ATR on Quality Control Check Report. (Apartments)

Quality Control Check Report.				Stage: After Finishing Stage III (Apartments)	
Flat No	H-601	Other		Sl. No.	42820
Company	M&M-UP	Project	—	Phase	—
Prepared by	Saikian	Sign	GMR	Date	27/02/2024
Project Manager	Aburuder	Sign	[Signature]	Date	27/02/2024
Previous stage report no.	42762	Report filed and signed by PM		☒ Yes ☐ No	
Checked By MD on		MD Sign		For filling	☐ Yes ☐ No
Recommendation: ☐ Stop further work. Submit ATR on QC report to QC team. Proceed only after recheck by QC. ☒ Stop further work. Proceed with work after submitting ATR on QC report to QC team. ☐ Proceed with further work only after making corrections pointed out in the QC report. ATR not required. ☐ Proceed with further work. ATR not required.					
Inspection should be done after : • Completing stage II works. • Complete works like doors, windows, grills, electrical wiring, switches, french door glass, etc. • In case of modular kitchen provide platform, granite and dado and modular kitchen in this stage. • Provide video door phone in this stage. • Possession for wood work cannot be given until QC check for stage III is completed and all corrections mentioned in th

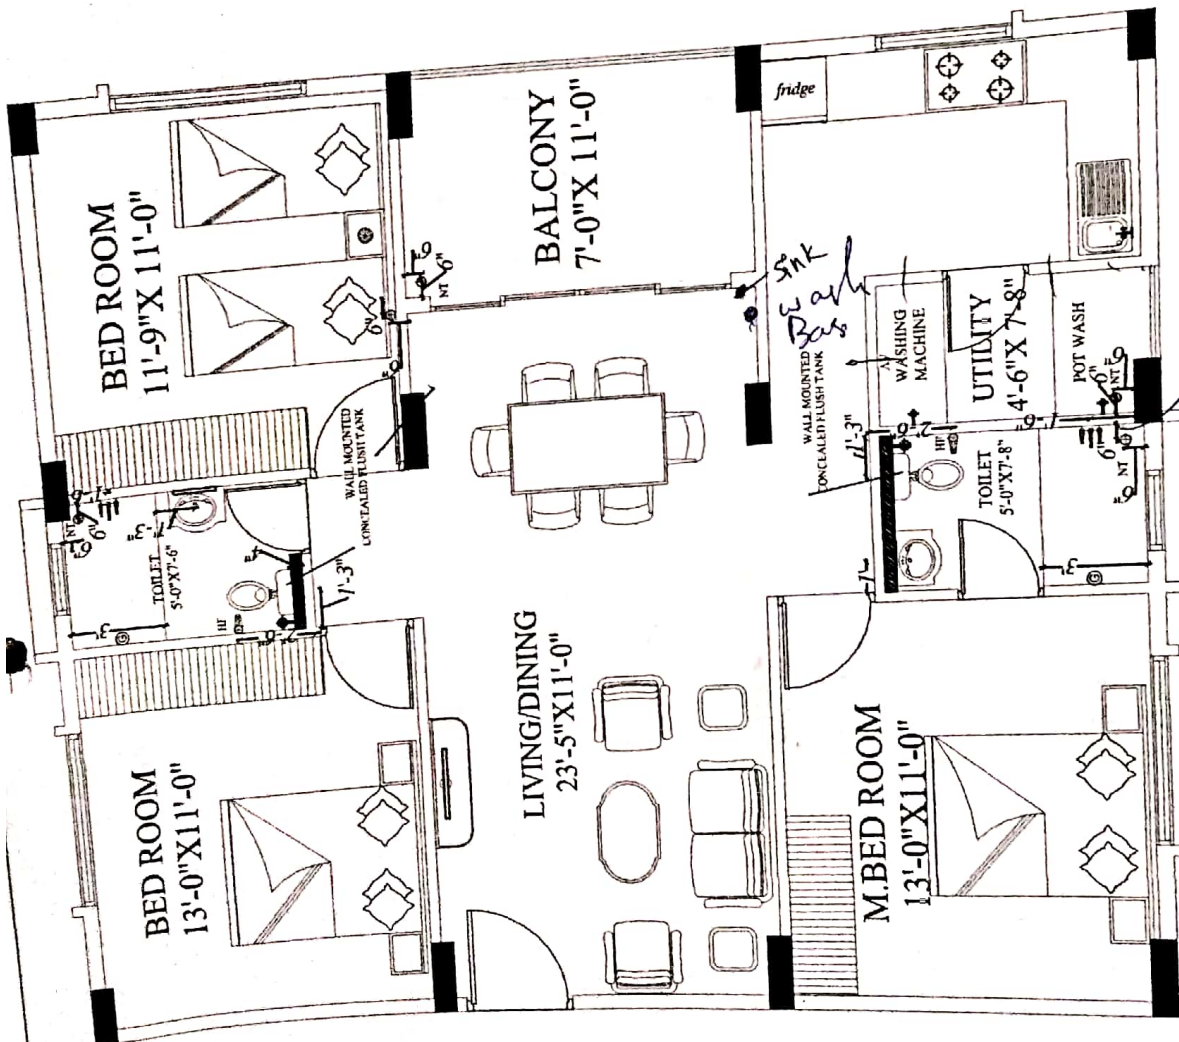
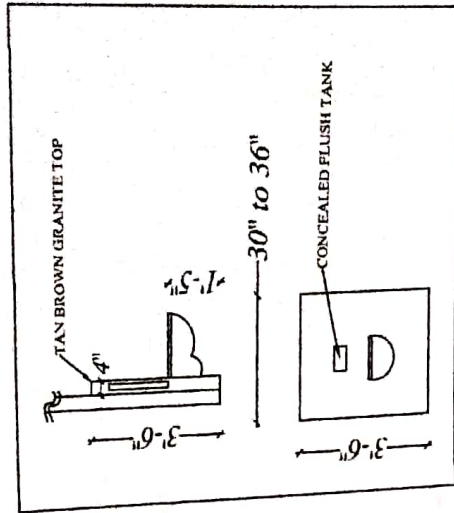
changes in kitchen platform: (mark on plan)

→ kitchen granite provided by customer.

Other Changes:

→ All door frames by customer
→ Brickwork shown in plan.

ELECTRICAL PLAN -1360 sq ft FLATS-A2 TYPE

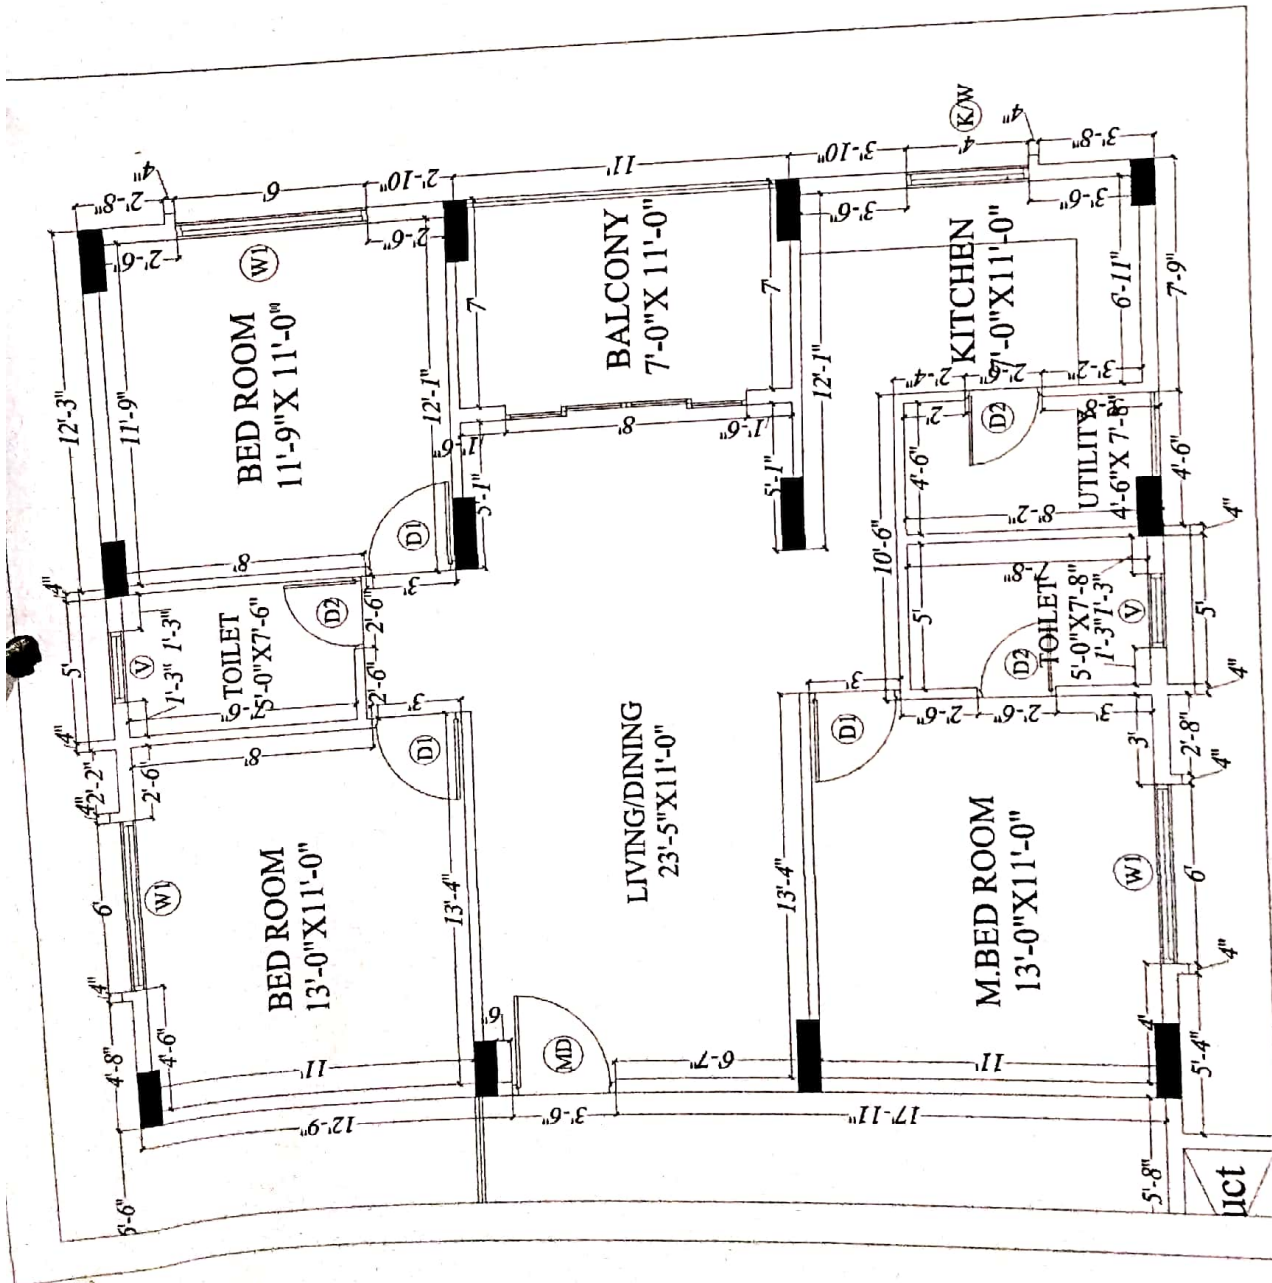
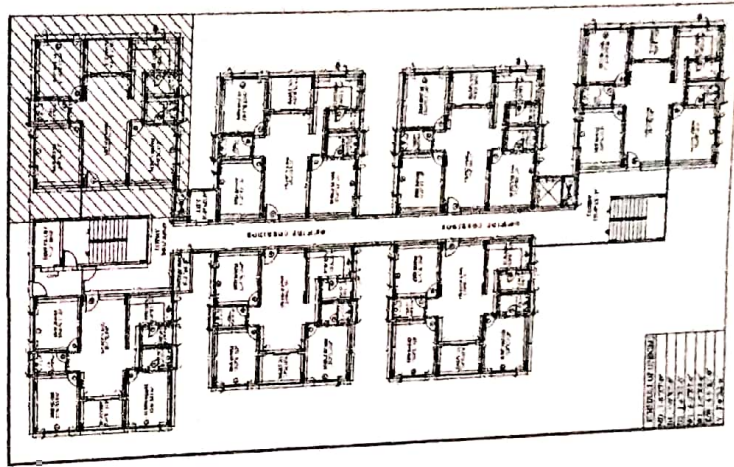
Changes in electrical points: (mark on plan)

① 32 Amps ^{2 pole} MCB for Common Bathroom with
459V MM Wiring → 1.5mm MM wire.

② Extra AC point at Main Door Side.

③ Electric point in Master Bathroom for Bath tub.
